MAINE TURNPIKE AUTHORITY

ADDENDUM NO. 1

CONTRACT 2016.02

GRAY INTERCHANGE

**PRELIMINARY FOUNDATION FOR  
 CANTILEVER TYPE SIGN STRUCTURES**  
 NOT FOR CONSTRUCTION - CONTRACTOR RESPONSIBLE FOR FINAL DESIGN

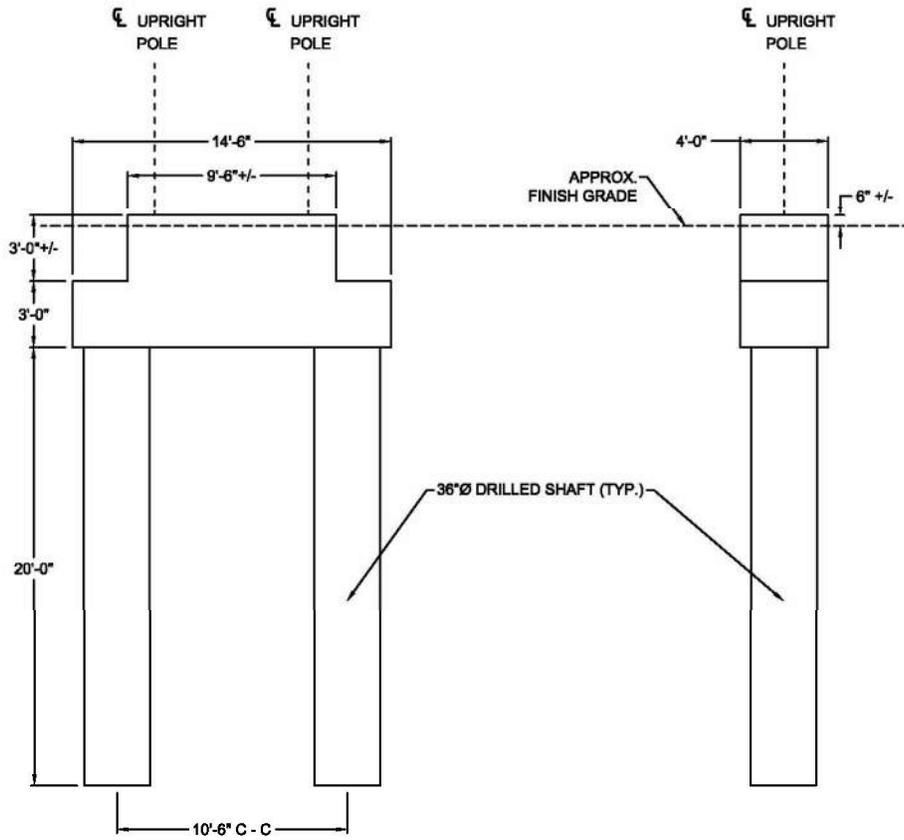
The Contractor shall select and design a foundation system for the sign structures in accordance with actual soil conditions as indicated in the geotechnical engineering report and the subsurface explorations. Preliminary foundation sizes and layouts have been provided as part of the contract documents. See the figures following this Special Provision for the preliminary foundation sizes. The Contractor shall provide final foundation system designs for each sign structure that can be constructed within the limitations of the existing rights-of-way and without impact to adjacent utilities. The construction of the new foundations shall include protections for the existing utilities as required by the Utility Companies or as directed by the Resident.
